The U.S. Environmental Protection Agency (EPA), the City of Chicago, and Technical Outreach Services for Communities (TOSC) have reviewed the July 1998 "Risk Management Plan- Dutch Boy Site". The EPA hereby approves the document with the following modifications, which are listed in Section A below:

**To:** Maple Park/Victory Heights Advisory Council  
**From:** Technical Outreach Services for Communities (TOSC)  
**Date:** September 10, 1998  
**Subject:** Comments on the document entitled "Risk Management Plan, Dutch Boy Site" dated July 1998

BOREHOLE-BASED AREAL EXTENT  
OF CONTAMINATION POLYGONS  
DUTCH BOY SITE  
CHICAGO, ILLINOIS

**RE:** City of Chicago's comments -- NL Industries, Inc.'s *Risk Management Plan - Dutch Boy Site*, USEPA Unilateral Administrative Order V-W-96-C-347

BOREHOLE-BASED AREAL EXTENT  
OF CONTAMINATION POLYGONS  
DUTCH BOY SITE  
CHICAGO, ILLINOIS

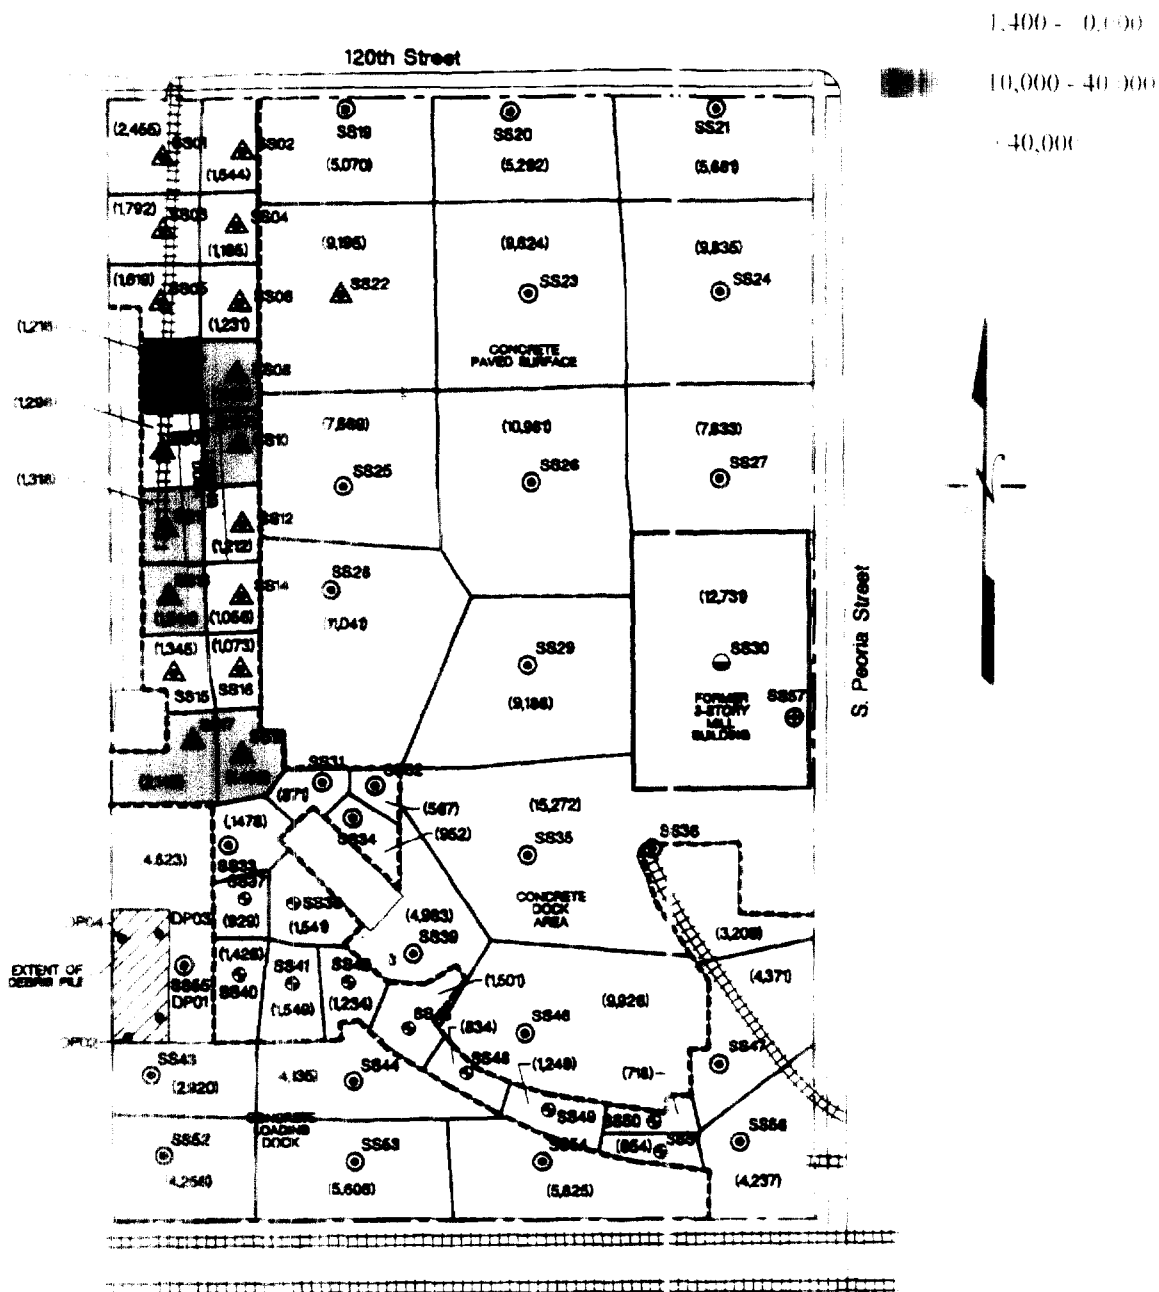
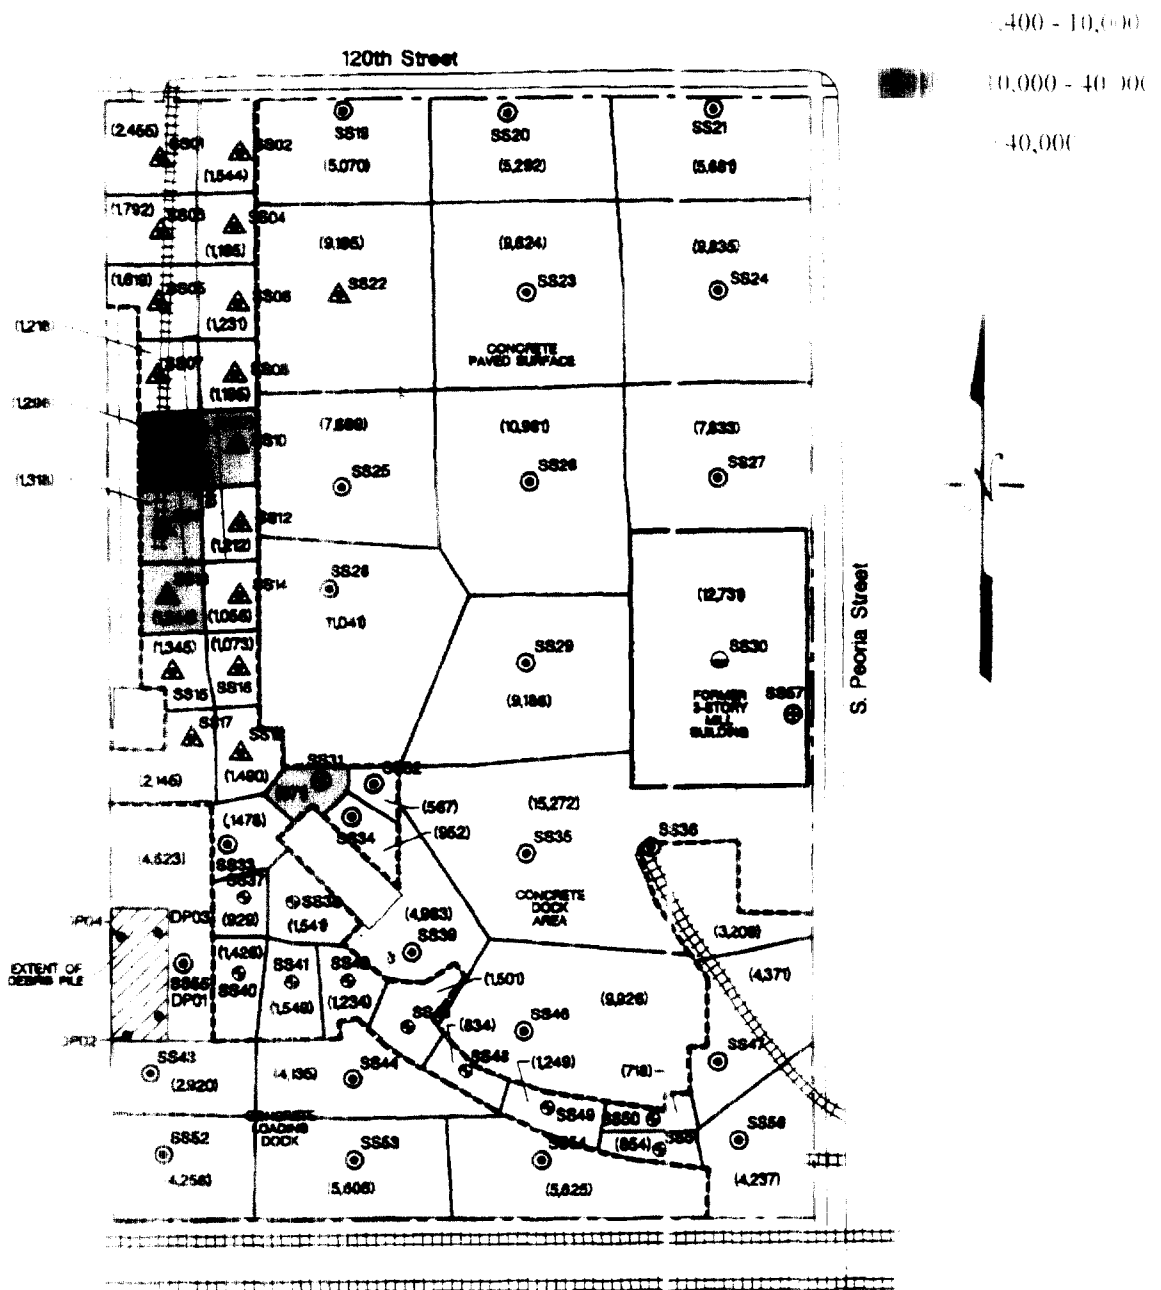
It would be more accurate to say that the most affected areas are the unpaved portions in the western region of the site and the paved areas under and adjacent to the former mill building. Additionally, Figure 3 is not sufficiently illustrative of the extent of contamination. We have scanned and modified Figure 4 to create three figures that better depict the extent of vertical and horizontal contamination (see attached).

<sup>c</sup> The area listed in the Table 2 of the RMP conflicts with the area listed in Figure 4.
